Report on Walking routes in Newry City Centre

April 2014

About this report

Kildare Street

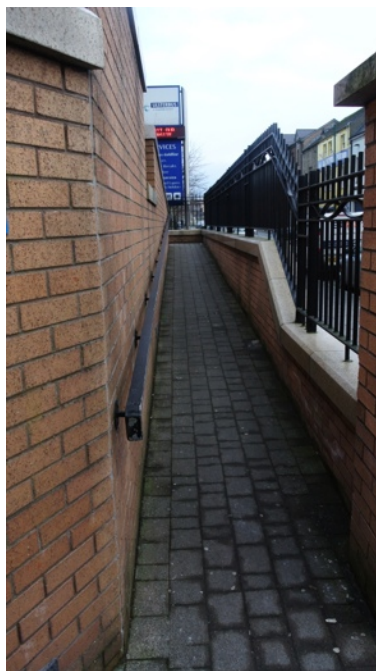
- 1 The pavements at the northern end and eastern side of Kildare Street are broad with furniture located in a line beside the kerb.

- 2 There is an uncontrolled crossing at the northern end of Kildare Street at its junction with Upper Water Street, Sugar Island and Trevor Hill. The tactile paving is incorrectly laid and in poor state of repair. Given the heavy traffic in the area using this crossing safely is likely to be challenging for some older and disabled people.

- 3 The pavement on the western side of Kildare Street adjacent to the canal is broad. However there are different surface types used in the area and the random location of furniture may make navigation difficult for people with a visual impairment.

- 4 There is a controlled crossing at the junction of Kildare Street and Bank Parade. The crossing does not meet acceptable standards with no tactile paving provided at all, control boxes poorly located and no tactile rotating cone.

- 5 Proceeding south on Kildare Street the pavements are relatively broad and a good state of repair. There is a significant crossfall on the eastern side.

- 6 The pavement on the eastern side narrows considerably approaching the junction with Margaret Square. Dropped kerbs have been provided at this busy junction but no tactile paving included. Signage poles have been placed in the middle of the dropped kerb. Pavement cafes restrict an already narrow pavement.

- 7 On the pavement at the western side of the Margaret Square there is no dropped kerb in line with the dropped kerb provided on the eastern side.

- 8 At the junction of the bridge linking Kildare Street with Monaghan Street dropped kerbs have been provided. These are not inline and have no tactile paving. The dropped kerbs direct people into the middle of a very busy junction and therefore represent a hazard.

- 9 Proceeding in a southerly direction the pavement on the eastern side of Kildare Street narrows considerably following the junction with Margaret Square. Bins provide a frequent and random obstruction.

Hill Street

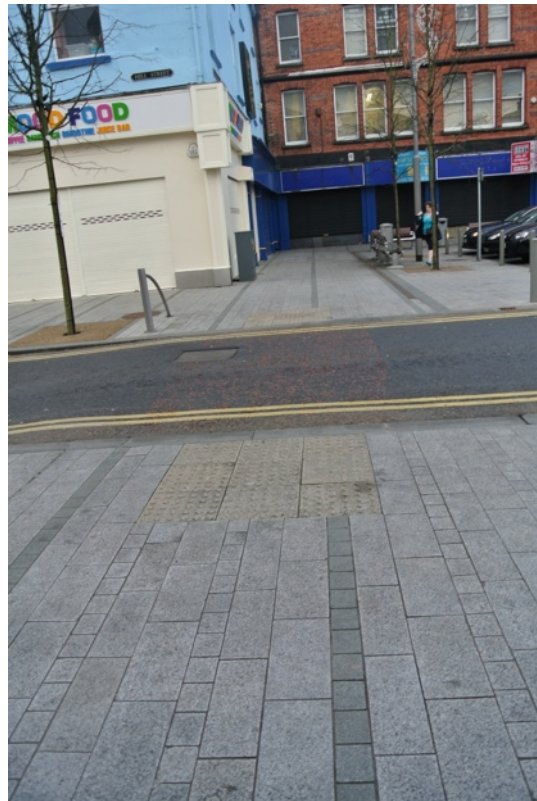
- 19 The pavements at the northern end of Hill Street are generally broad, of reasonable quality and generally clutter free. There is no accessible opportunity to cross Hill Street at the junction with Kildare Street or along Hill Street until the junction with Margaret Square.

- 20 A recent public realm scheme has improved surfaces around Margaret Square. The square is busy with parking for taxis and cars. There are no kerbs in the area with dish drainage channels used to delineate between the flush road and pedestrian surfaces. This type of delineation is not something Imtac would recommend.

- 21 There are four in-line controlled crossings on the square. These follow good practice in relation to the provision of this type of crossing. However given the “shared” nature of the area consideration should be given to extending the length of the tactile paving at these crossings.

- 22 Street furniture has been used to mark out clear pedestrian routes in the square. However accessibility and safety in the area would be enhanced by the inclusion of visibility bands on bollards and other furniture.
